# Request for Review of Airservices Australia's Responses Regarding Flight Path Change Proposal (3015)

By *Dr Anahita Sal Moslehian* PHD, EDAC

Figure 14: Shifting the turning point slightly to the West-Gate bridge and M1

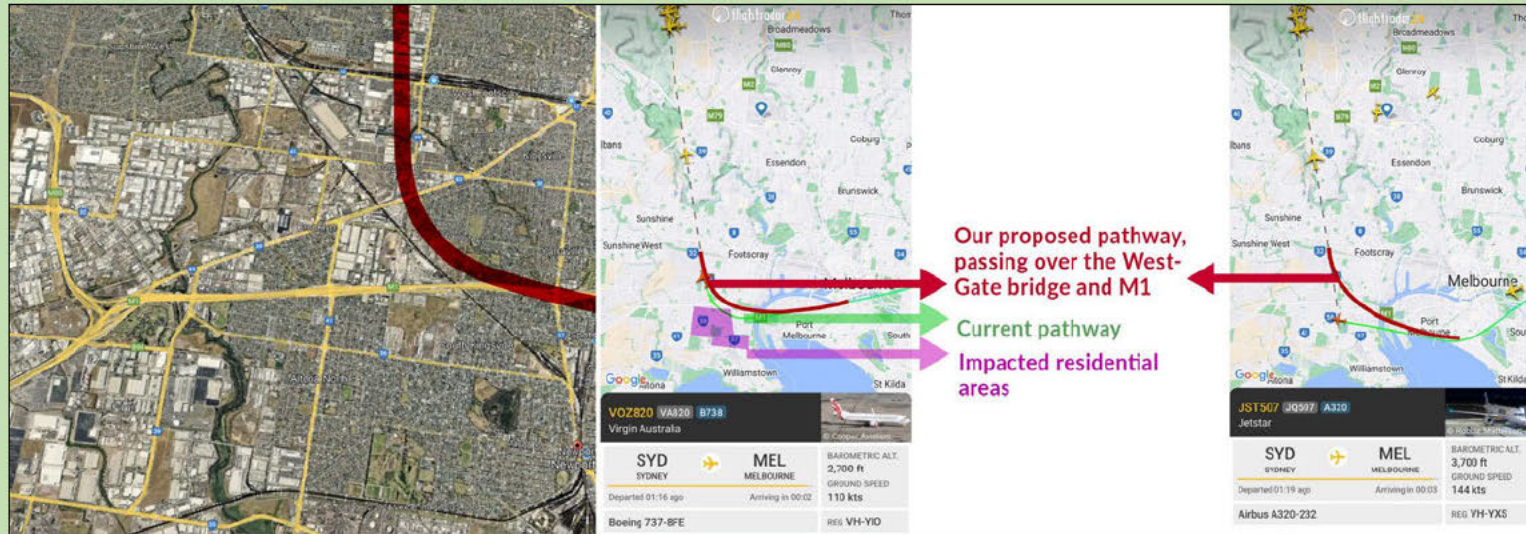
Suggestion 2: As shown in Figure 14, we propose a second minor adjustment to the current flight path, directing aircraft over the **West-Gate bridge and M1** – residential areas. Although the changes may seem minimal, they will reduce the noise impact for many residents in the area.
